KINGS BRANCH SUBDIVISION, PHASE TWO

APPLICATION NUMBER 2 DATE July 5, 2007

DETAIL SITE PLAN

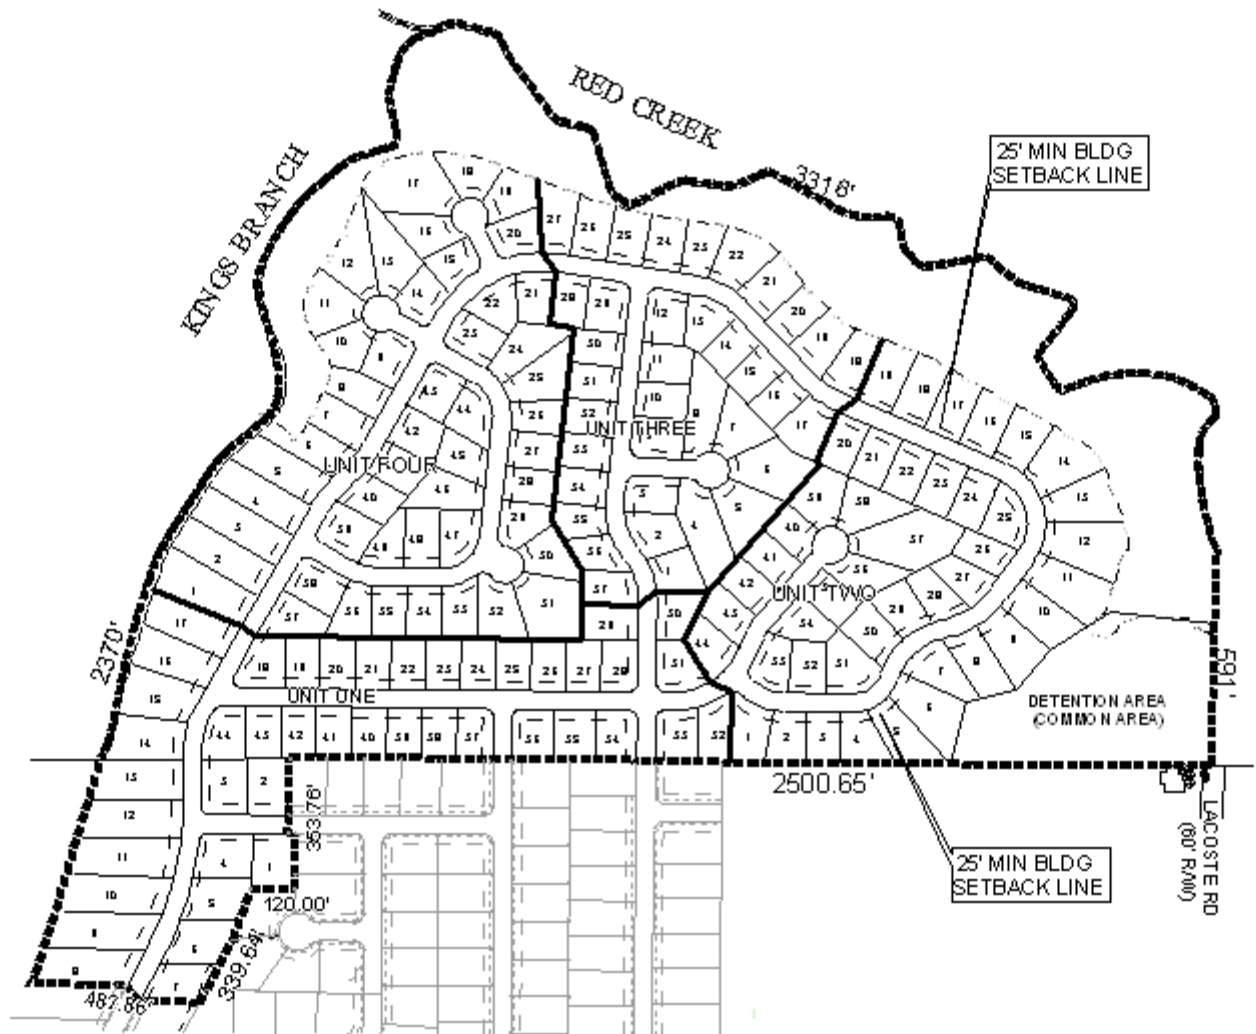
A revised plat and mailing labels were provided by the applicant. The revised plat depicts a 174-lot subdivision with detention areas (common areas). The original proposed depicted 175 lots, however the proposed Lot 175 is now labeled as a detention area (common area), and only has 25-feet of frontage onto La Coste Road.

The plat depicts that some of the detention areas may occur within the Zone “AE” floodplain, which is not allowed by the City of Mobile storm water and flood control ordinances. A note should be placed on the plat stating that all detention areas must be located outside of the Zone “AE” floodplain.

The revised plat reflects the comments and notation requirements of the holdover. It appears that all lots will meet the minimum standards of the Subdivision Regulations.

A condition of the original approval in January 2005 was that all common areas have a minimum of 25-feet of access onto a public street. It appears that the only access from a public street is via La Coste Road, thus the plat should be revised to ensure that the common areas have the minimum requested access. It should also be pointed out that the detention areas should have drainage easement access to streets internal to the subdivision so that vehicles requiring access for maintenance purposes will be able to do so.

- 1) revision of the plat to add a note stating that all detention areas must be located outside of the Zone “AE” floodplain;*
- 2) revision of the plat to ensure that all common areas, including detention areas, are clearly labeled;*

- 3) revision of the plat to ensure that all common areas have a minimum of 25-feet of access onto a public street;*
- 4) revision of the plat to depict drainage access easements near the proposed detention areas, to allow for access to the detention areas for maintenance from streets within the subdivision;*
